SUMMARY OF MODIFICATIONS

WATER SYSTEMS

PSS CRITICAL COMPONENTS

Presented at TWG Meeting, Thursday, June 17, 2004

**ORIGINAL WATER CIRCUIT FOR
BEAMLINE PSS COMPONENTS WITH MESH
(I.E. FLOW AND DP MEASUREMENTS)**

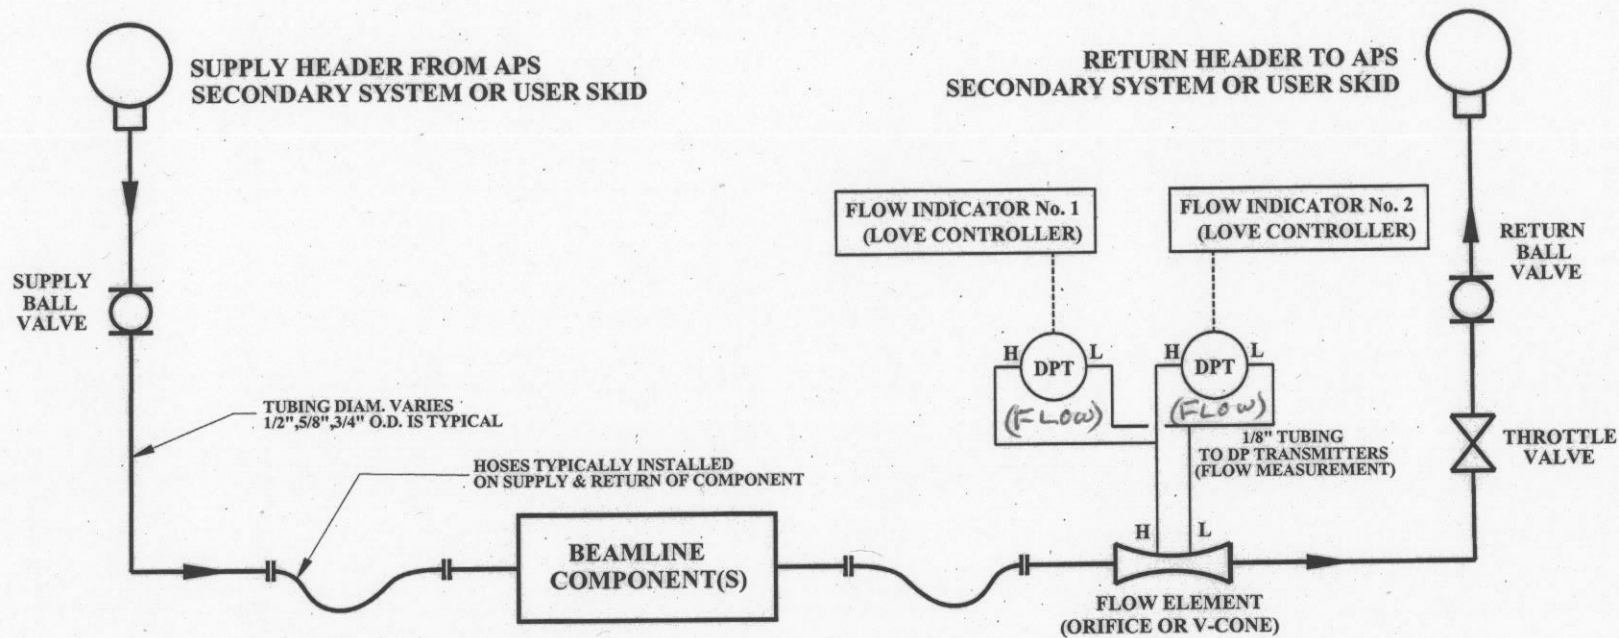
1. REPLACE “DP” TRANSMITTERS WITH “FLOW” TRANSMITTERS

2. REMOVE HIGH FLOW TRIPS

3. REPLACE VIATRAN TRANSMITTERS WITH YOKAGAWA AND RELOCATE TO S.R. MEZZANINE

**CURRENT WATER CIRCUIT FOR
ALL BEAMLINE PSS COMPONENTS
(REDUNDANT FLOW INSTRUMENTATION)**

PSS "FLOW" TRANSMITTERS
IN HOFFMAN BOX ON SR. MEZZANINE
AFTER RELOCATION (Sector 34-ID shown)

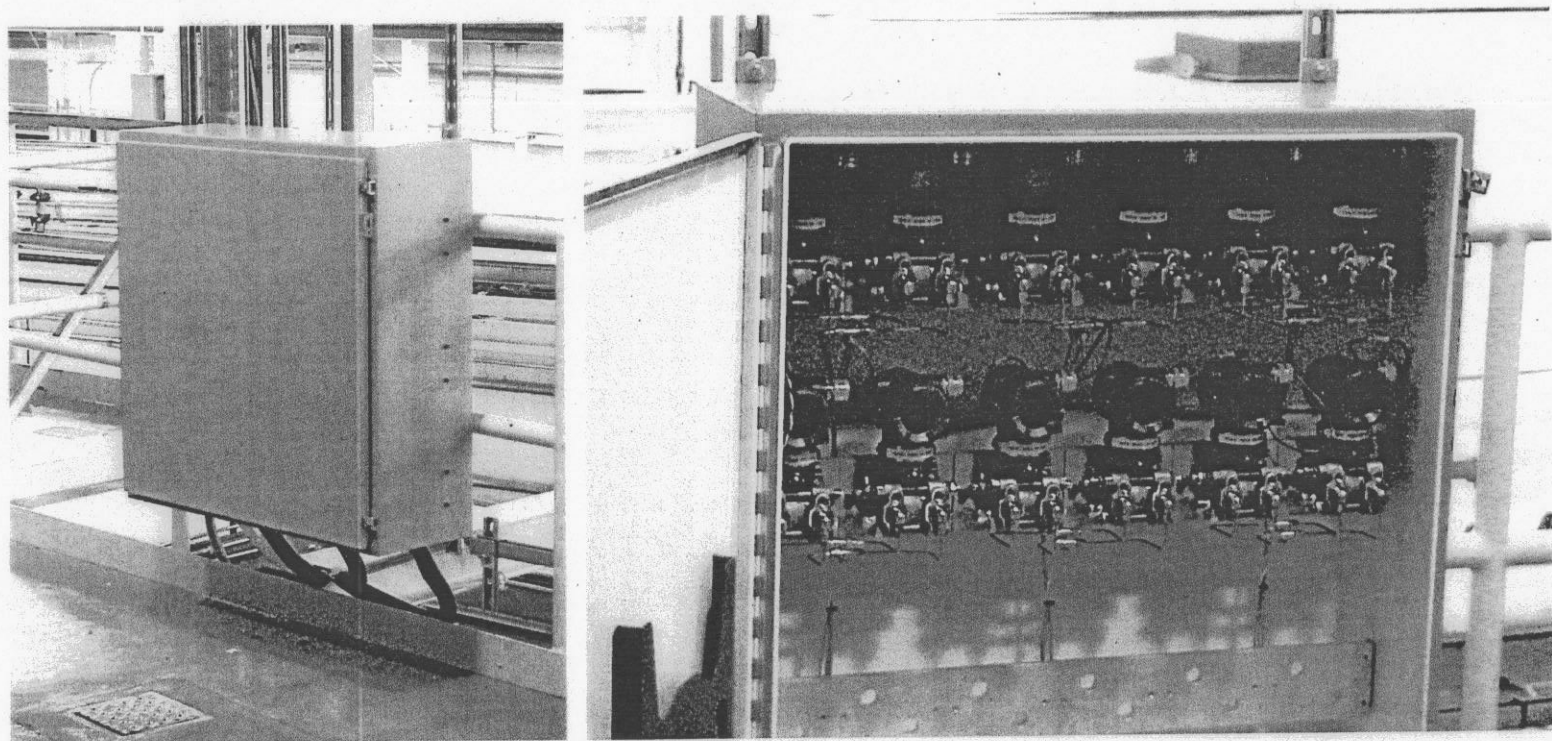
- ◆ **Complete in sectors 1-8, 11, 16, 23, 24, 34**
- ◆ **62% of all PSS transmitters**
- ◆ **Full completion ~ end of FY2005**
